Access Compliance Report Public Rights-of-Way (Curb Ramps)

Main Street: CORPORATE Cross Street: TERRACE_RD Location: NE

ADA ID: RPRK211115162145 Ramp Type: Type 4 - Parallel Initial Pass/Fail: Fail Overall Compliance: No Severity Score: 16

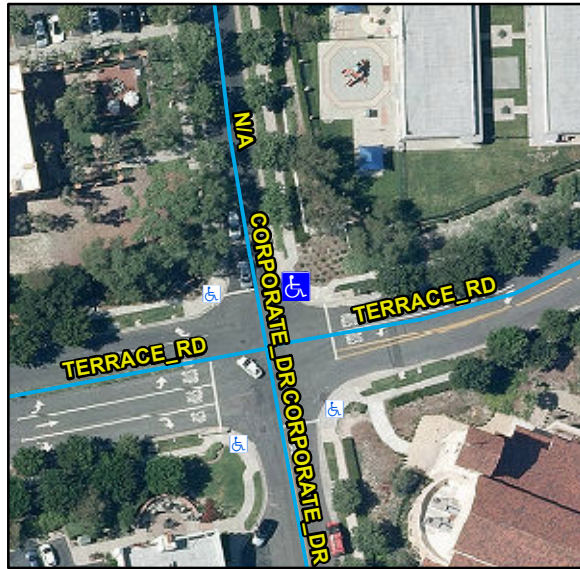
R204.3, R304.5.3, R304.3.2, STD 1115

Remove & Replace Curb Ramp With Two New Directional Ramps or Equivalent.
